KAWARTHA PINE RIDGE DISTRICT SCHOOL BOARD
PUR24-100-ITT
Murray Centennial Public School Addition

ADDENDUM NO. 3

Add (1): Architectural Addendum No. 2, Prepared by Moffet and Duncan Architects Inc. (34 Pages)

PHASE 2 & 3 DIAGRAM
A1.3 1:1000

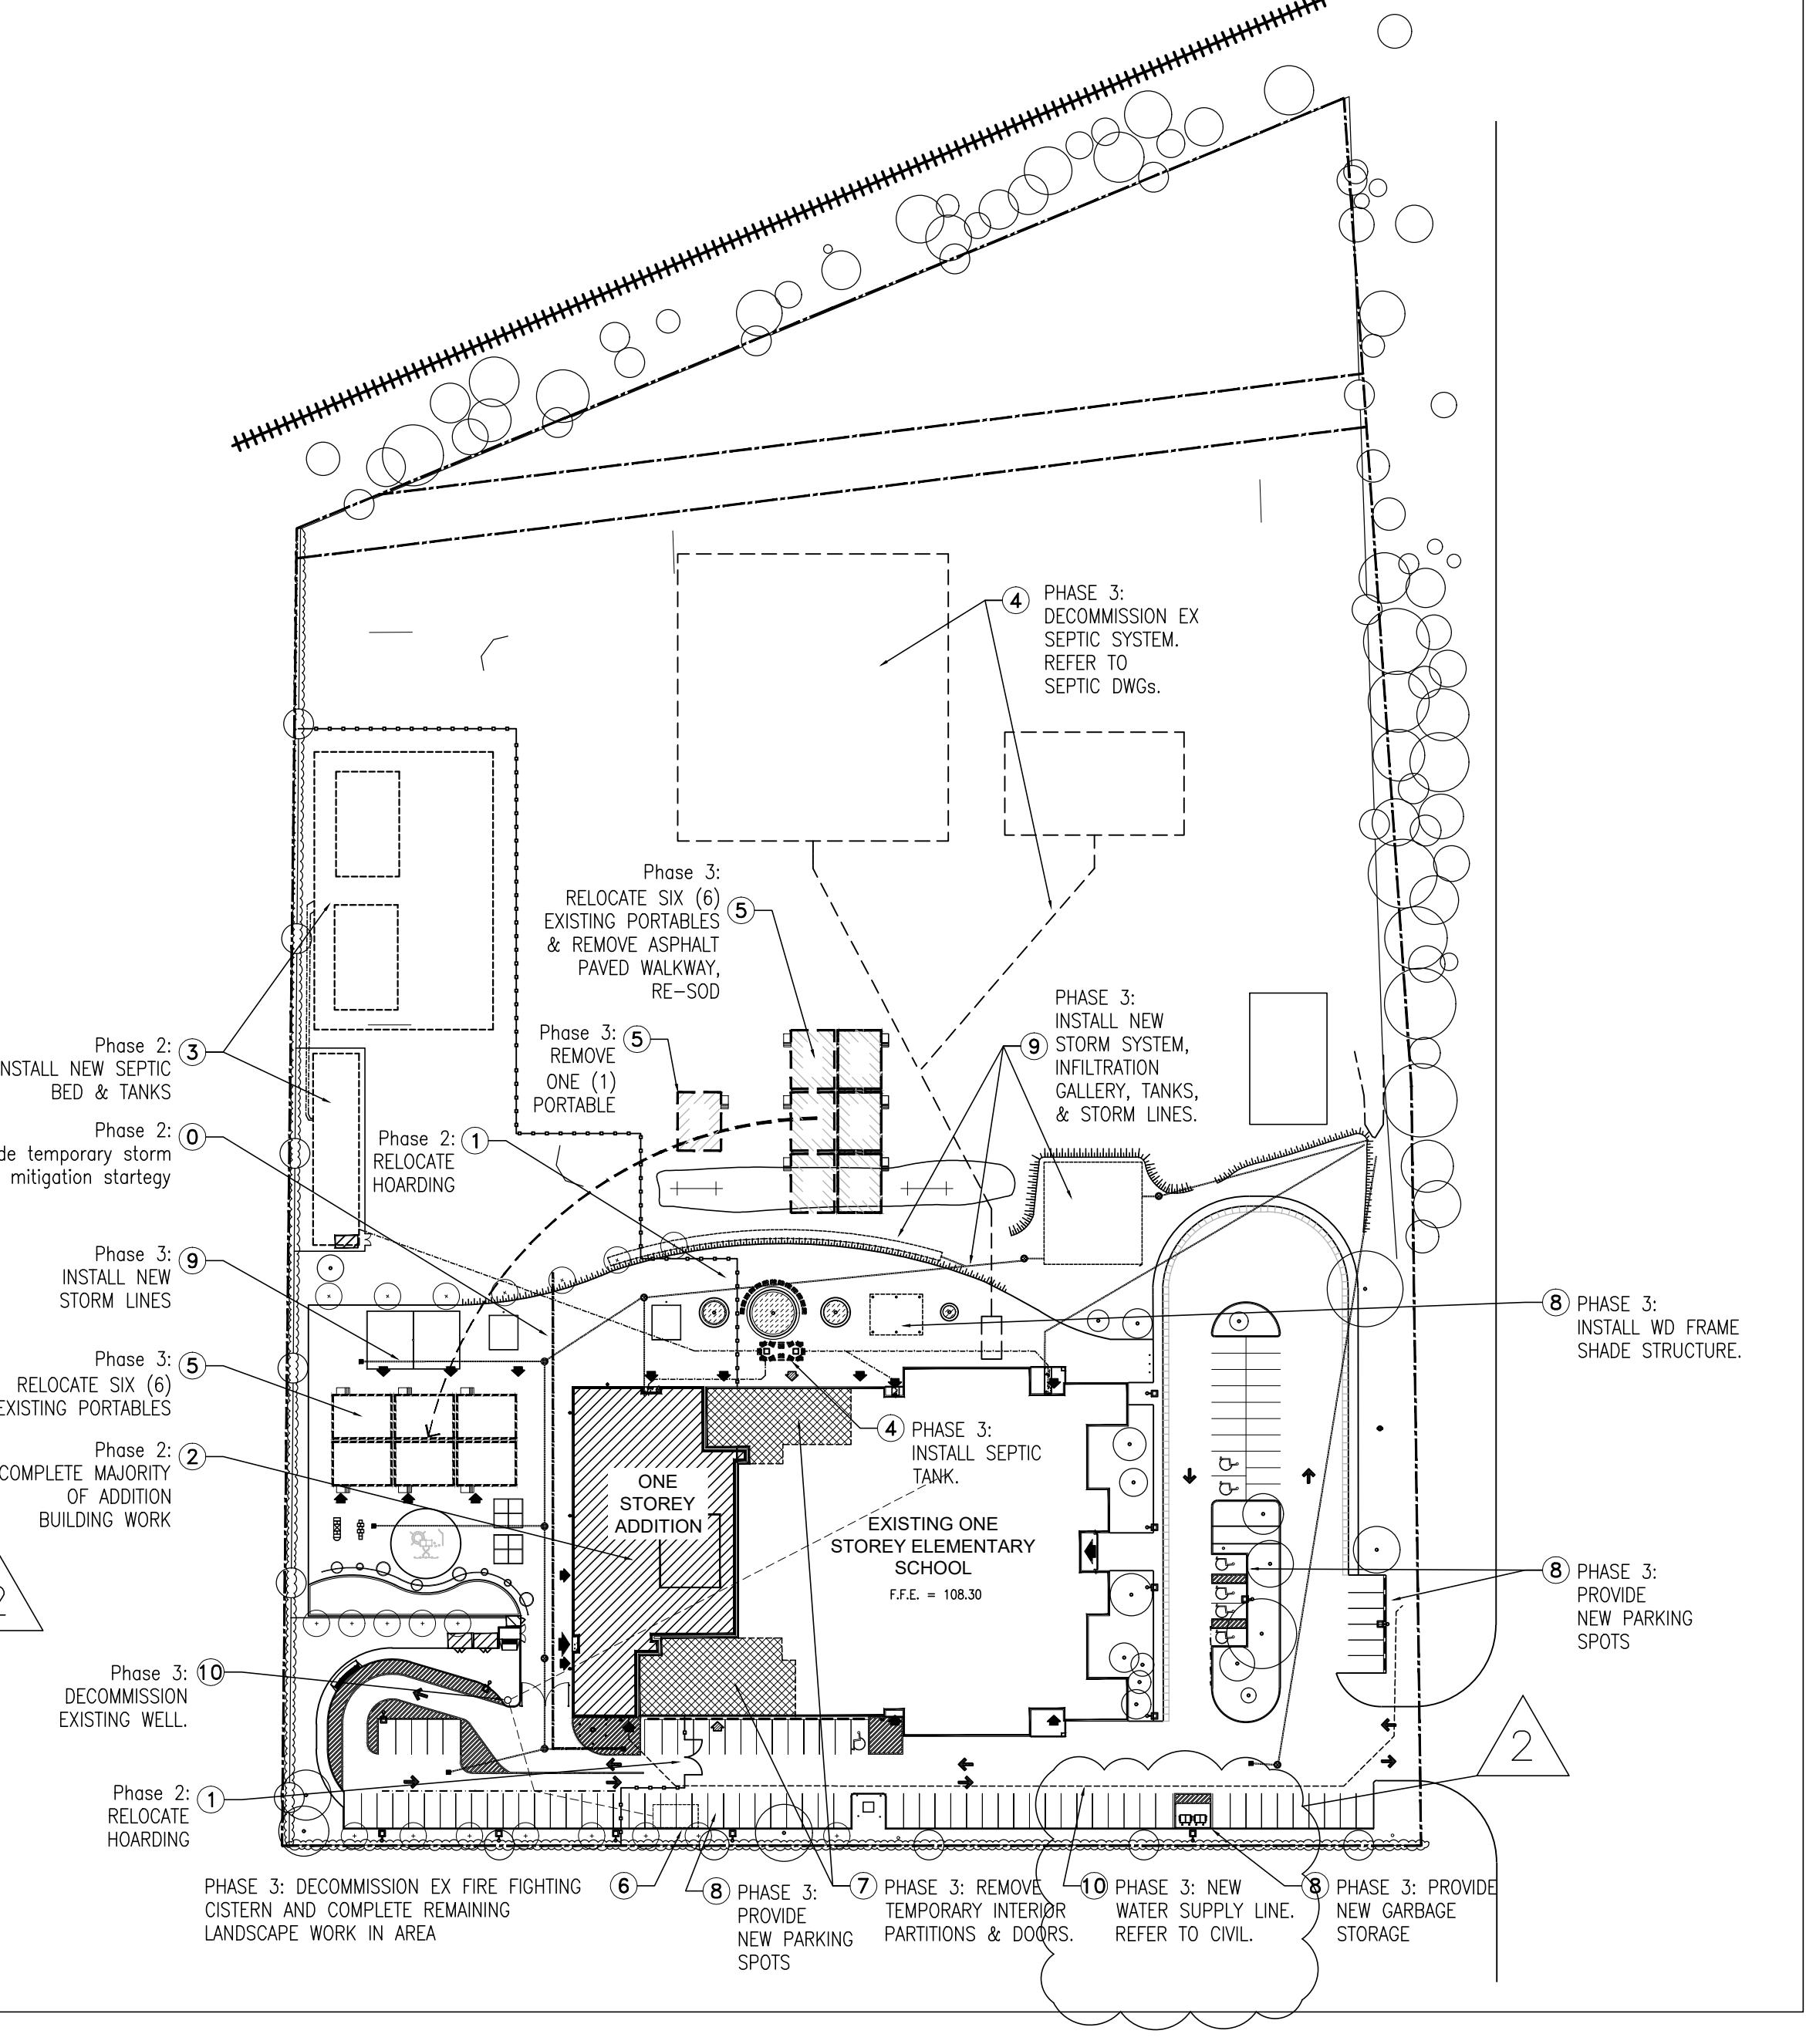
- .1 Replace Drawing A1.3 with enclosed Drawing A1.3 Addendum 2.
- .2 Refer to Dwg 1/A1.3 for revised note to remove and backfill existing septic tank & distribution box.
- .3 Refer to Dwg 1/A1.3 for revised note to decommission ex. fire fighting cistern.
- .4 Refer to Dwg 1/A1.3 for inclusion of existing underground hydro service to remain.
- .5 Refer to Dwg 3/A1.3 for inclusion of "Note 10" and inclusion of new water supply line.
